## Millcreek Township Planning Commission

Public Meeting Agenda

**Wednesday, March 12, 2014 4:00 P.M.**

**STAFF REPORT**

SITE PLAN  
3/32" = 1'-0"

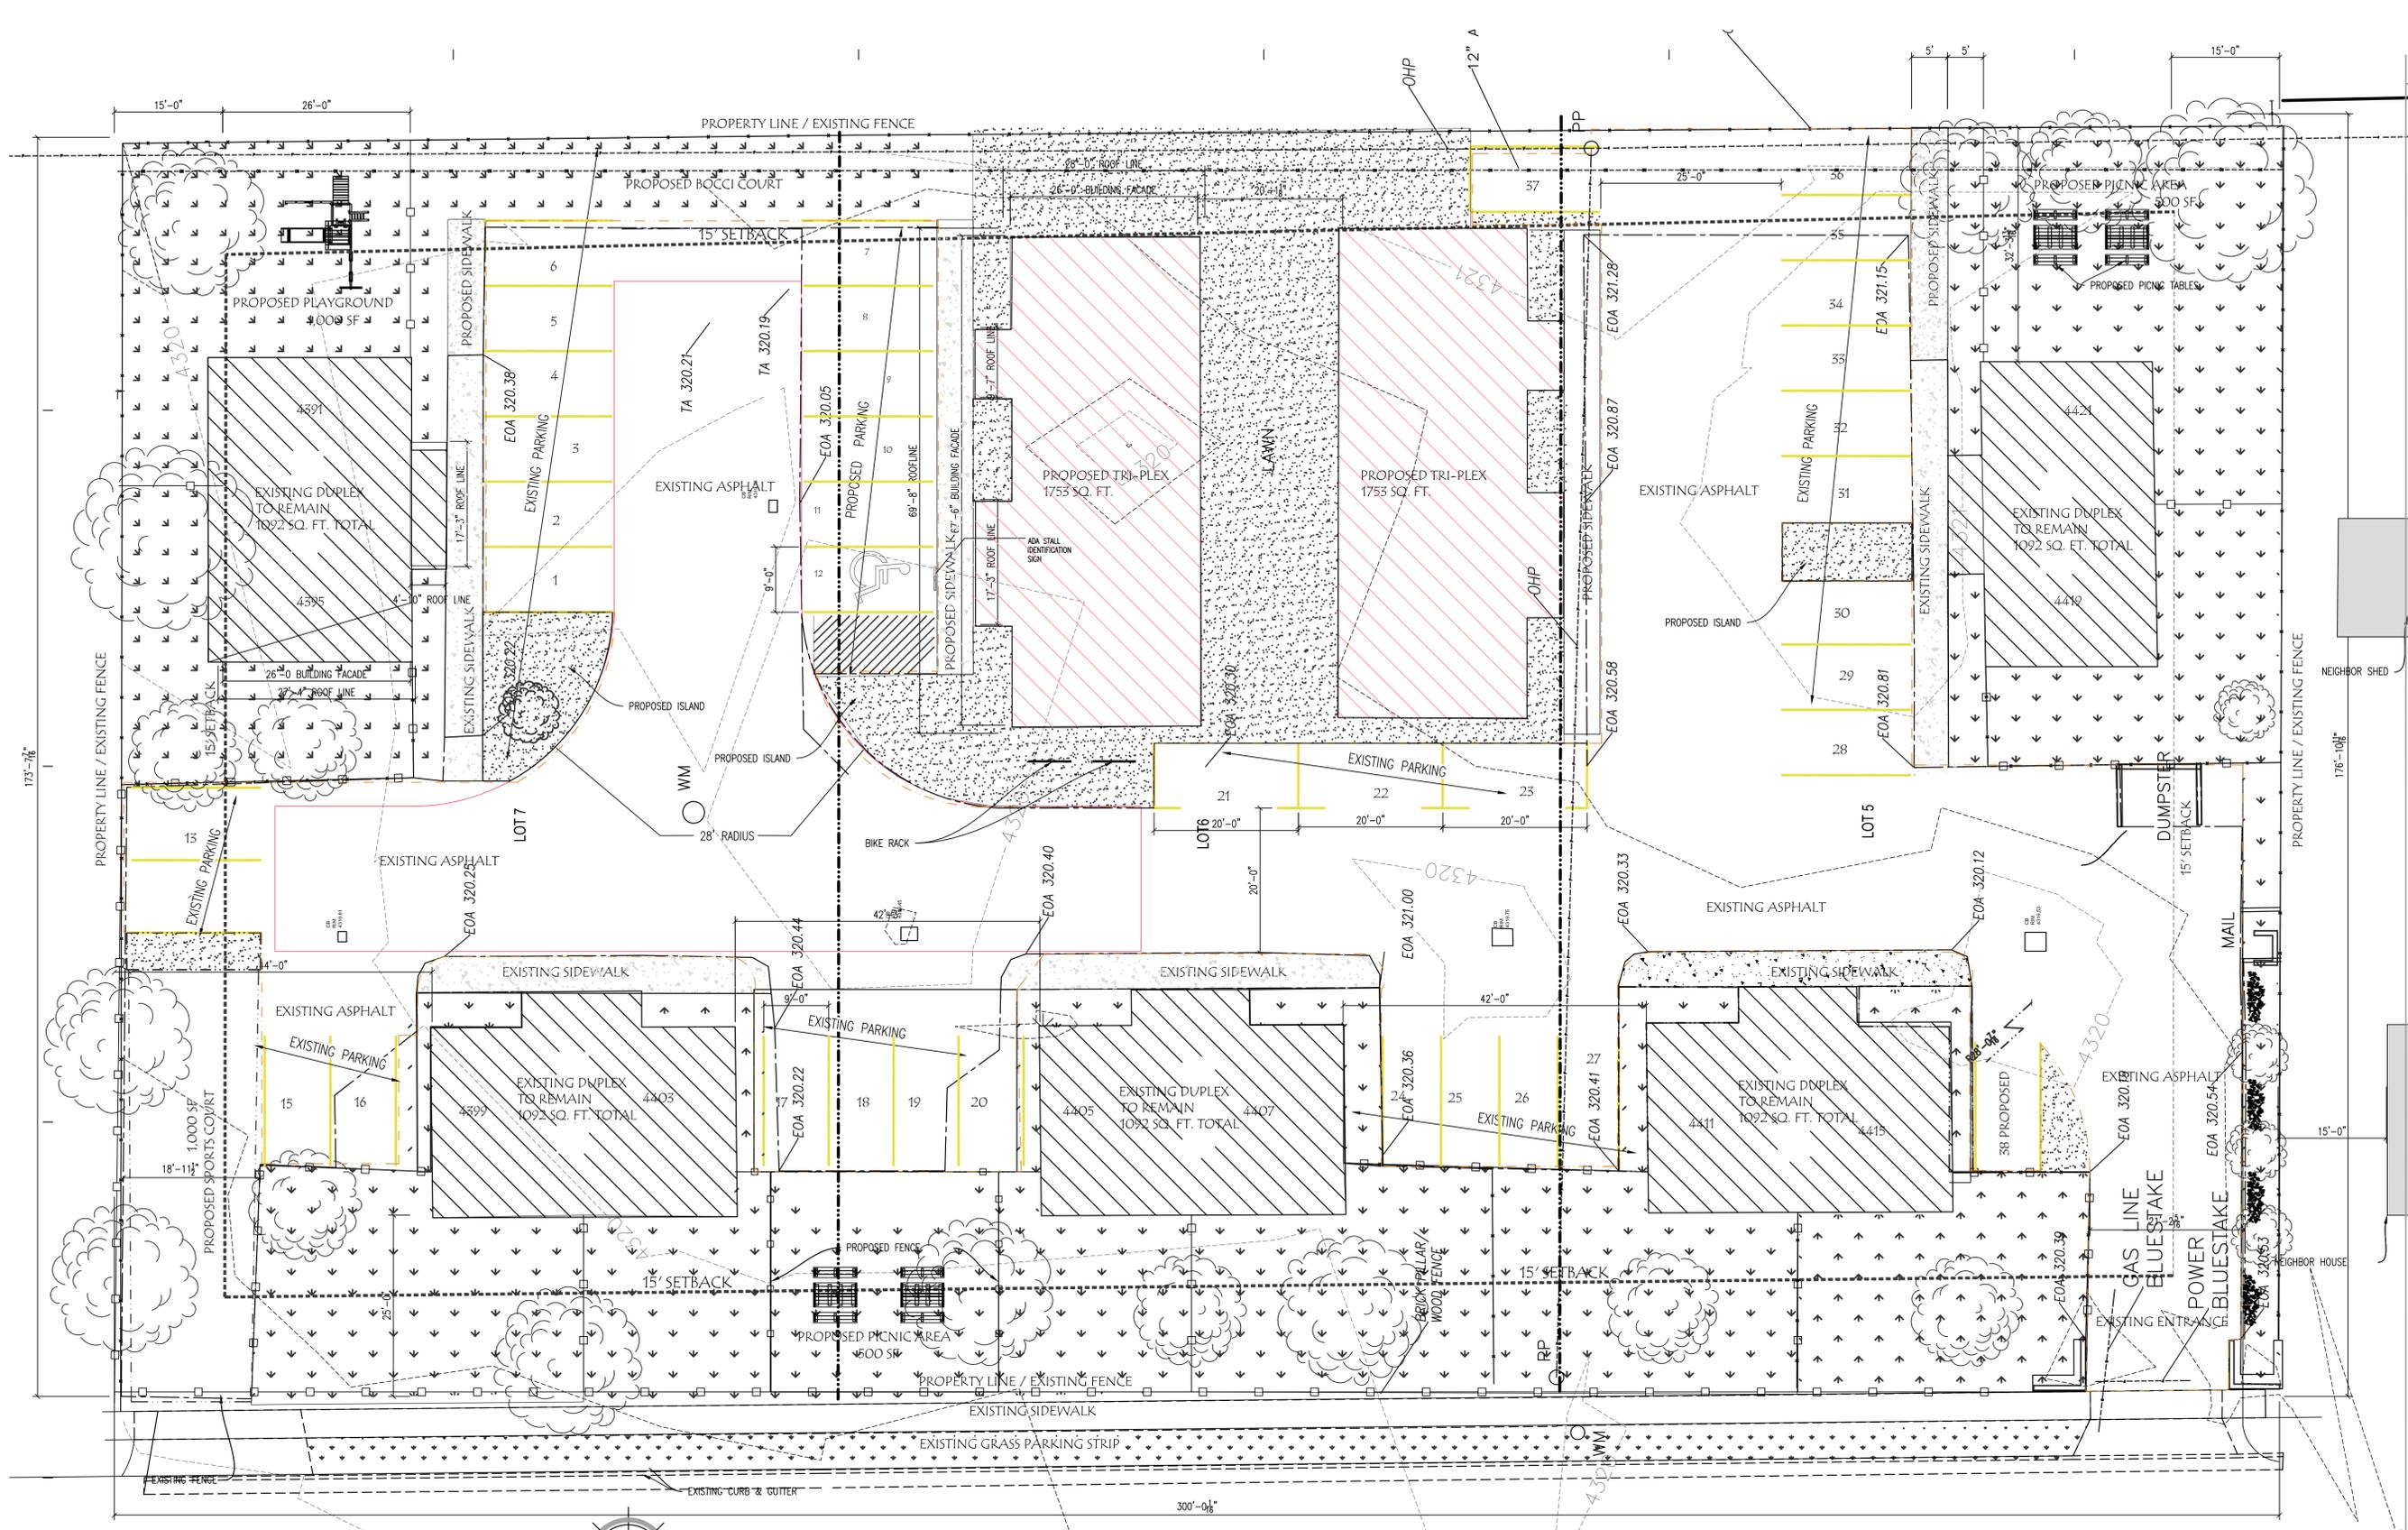
- 1- Site is located in an existing complex open space area
- 2- The are is known to have potential high ground water and poor soils
- 3- No building Exterior building elevations were submitted with packet
- 4- Will need to submit site grading and drainage plans for review and comment
- 5- A Geotechnical report is required at this time
- 6- Erosion control plans and BMP's will be required at the time of the building permits

\*Additional guest parking has been provided making 5 guest parking spaces plus a handicap space that is not currently on site. The amount of needed guest parking is determined by the planning commission.

- 1 )Additional fence height be added around the sports court to prevent balls or play equipment from entering the street.
- 2 )Existing fencing at location of proposed playground/tot lot be removed or changed to a fence that allows visibility into the playground with a gate. The same shall apply to the proposed picnic area on the south side of the project.

3900 South 1451 East  
PLANNED UNIT DEVELOPMENT

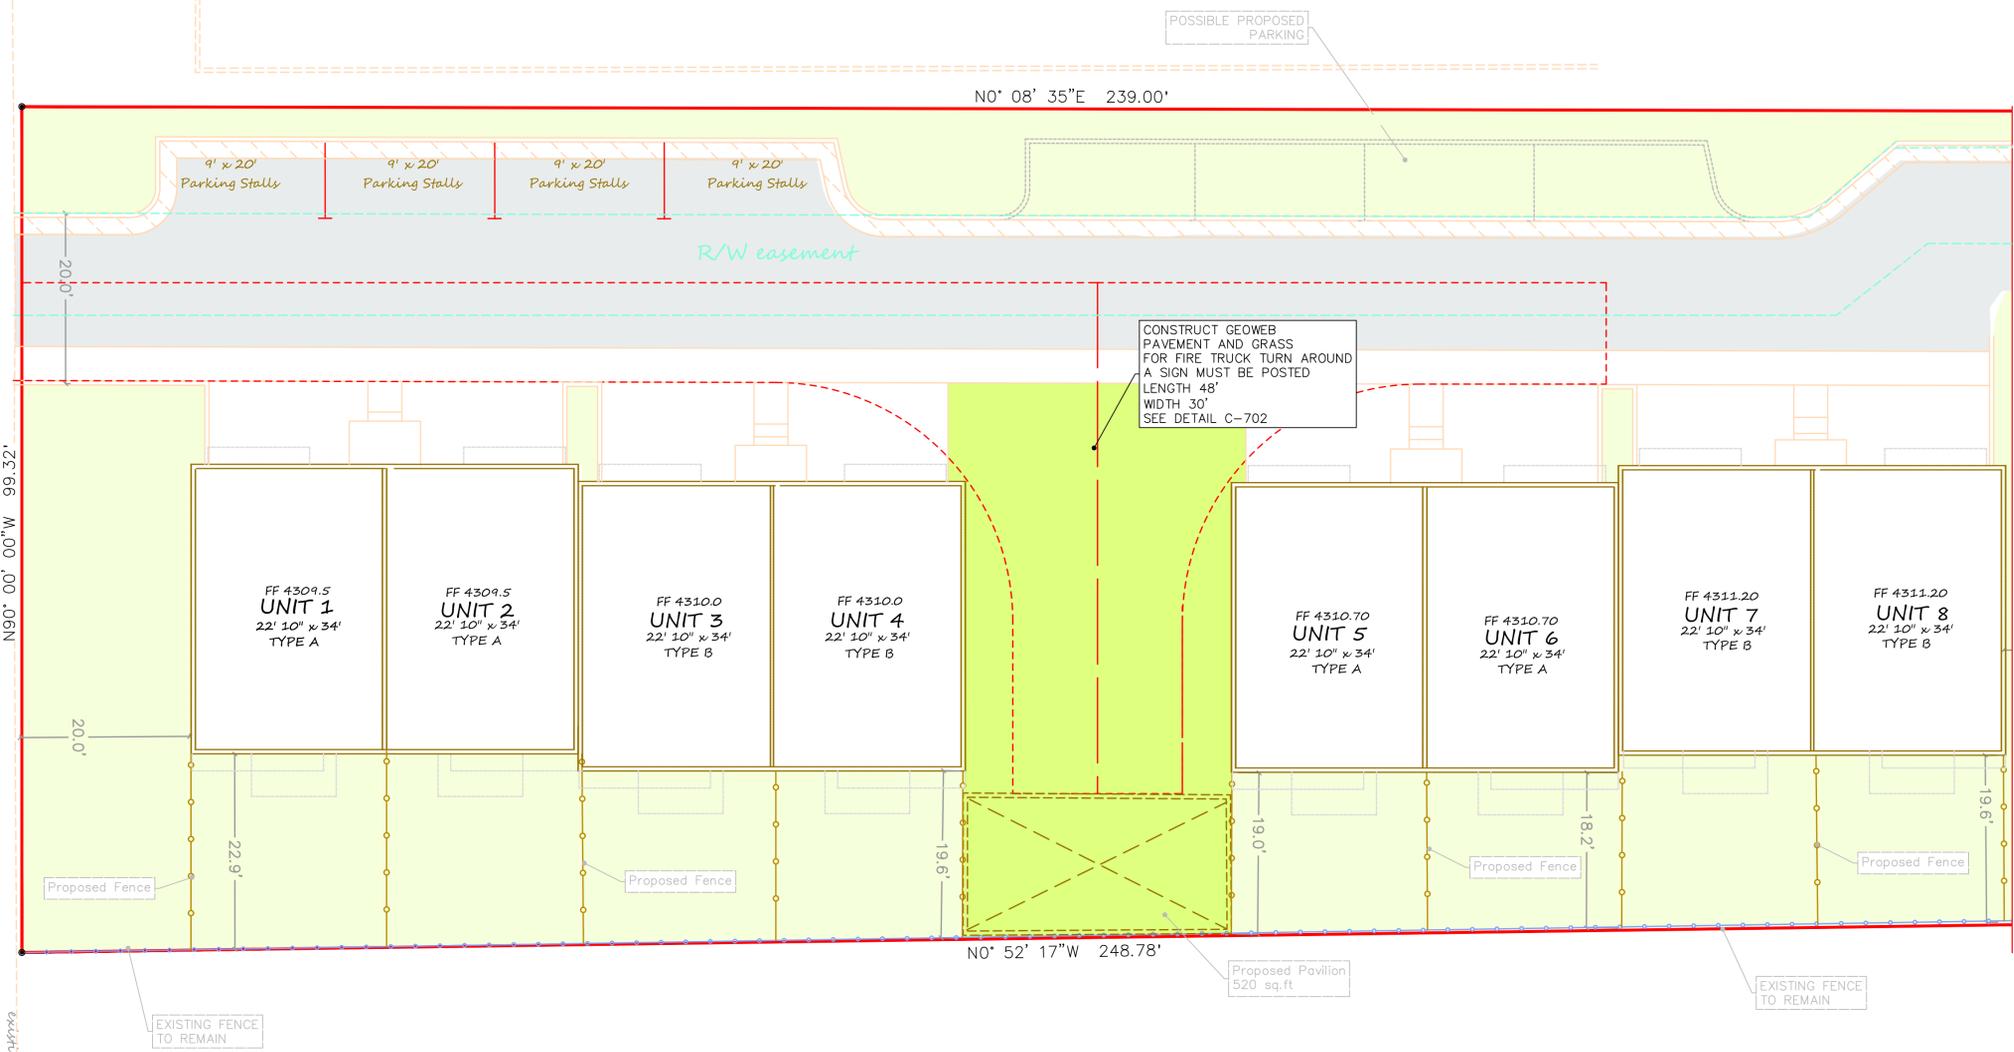
Show easement across property for existing access to the north.

Plan appears to be using sidewalk as part of 20' required roadway width. Sidewalk may not be included in width. The improvements are not clearly labeled on my plan, so determination on true width of road cannot be made.

Floor plans indicate the 2 car garage is 18'6" for first 10' or so then the garage expands to required 22' per 9'x18' stall plus 2' per side per walls. Technically only counts as 1 stall per structure other parallel stalls would be utilized to meet minimum parking. Still technically possible to park a second car on the proposed garage, but would have to be considered towards guest parking count as determined by PC.

Fence / Property Line a concern with neighbor to north. Surveyed line is used in plans, but existing fence not indicated.

comment in original staff reports notes that RM zone requires 30' rear yard... R-/21 zones.. 30' without covered parking, 15' with. Common practice in PUD to allow 15' perimeter setback. Any setback could be approved by the PC if deemed appropriate. Front setback only 20' can be approved smaller, typically 25 in RM zone.

Only 1 amenity. 520 sq. ft. ... playground idea removed. Planning commission to decide if satisfies open space and amenities standard.

Per site plan site has 43% open space... 10,430 sq. ft. of 24,058 sq. ft. Would drop to 38% if geo web pavers or pervious asphalt does not count as open space. Would drop to 30% to allow for correct turn around size and utilization of 'possible parking'. Would also require the pavilion / amenity space be reduced to allow for turnaround length.

- 7 ) The proposed pavilion shall be a minimum of 250 sq. ft.
- 8 ) Lighting from the development shall be screened and directed as to not directly shine on neighboring properties.

- 9 ) Additional turnaround space shall be provided on the north end of the property. This is not an emergency vehicle turnaround but should allow passenger cars to turnaround without using neighboring property.

DRAWING SCALE 1 in. = 20 FT.

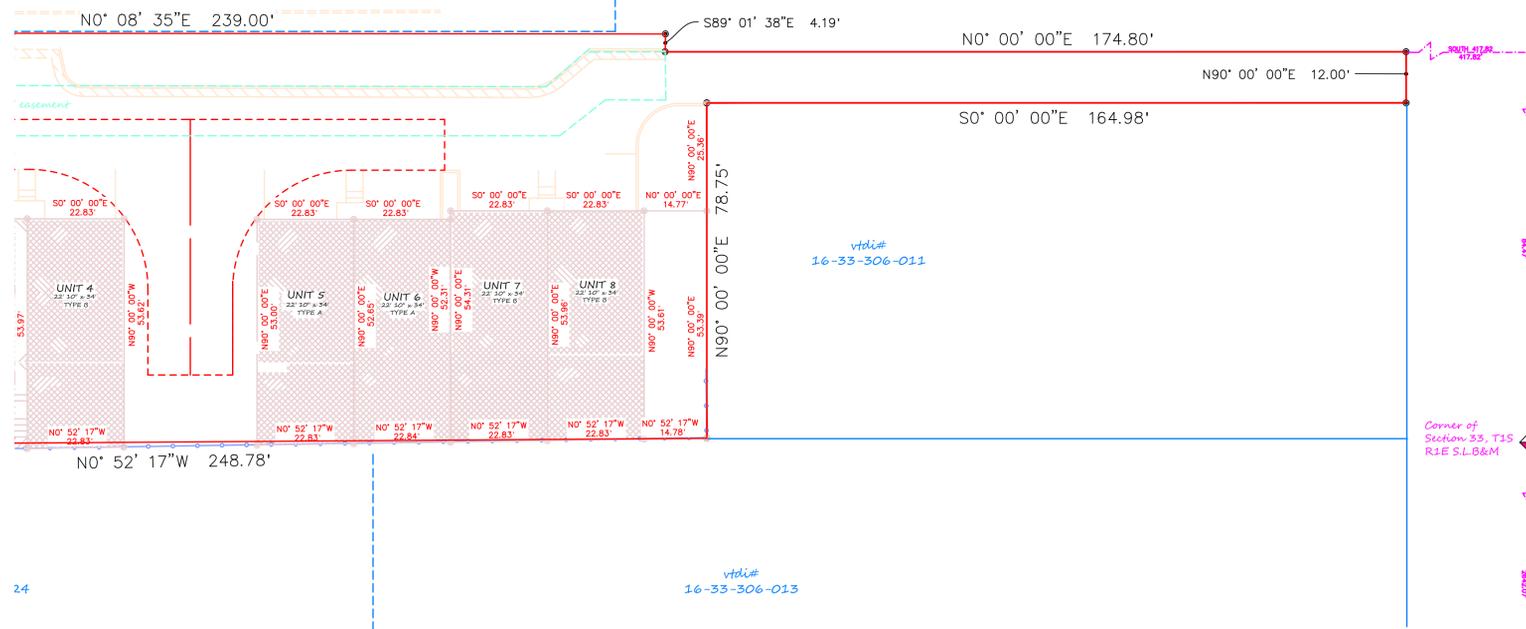
1. The RSC number on the preliminary plat does not correspond with the parcels in question. Record of Survey must be received by County Surveyor's office before plat can leave Planning and Development and the following statement A Record of Survey has been filed as #xxxxxxxxxxx in the S. L. County Surveyor's Office MUST be included in the Surveyor's Certificate on the final mylar, the x's being the RSC No. received from the County Surveyor's office

5. Show street name (Lemmon Ln) and coordinate for same on plat
6. Show Fire Hydrants on Final Plat along with distance to back line of subdivision by path of travel

11. Drive approach on east side of property must be removed and curb and gutter put in to match existing
12. County description shows frontage as 90.74 ft but drawing is showing 99.32 feet. Drawing also shows parking within Lemon Lane which is a private street that appears to be used by parcel north of subject parcels. Easement for ingress/egress for those parcels must be in place and travel can't be blocked by parked cars

13. Show tie from section corner to block corner on plat. Description on preliminary plat and drawing do not match at all. I think the block should be block 23 not 28 please check

14. The RSC number shown on preliminary plat is incorrect. Please show correct number on final plat
15. North arrow pointing in wrong direction
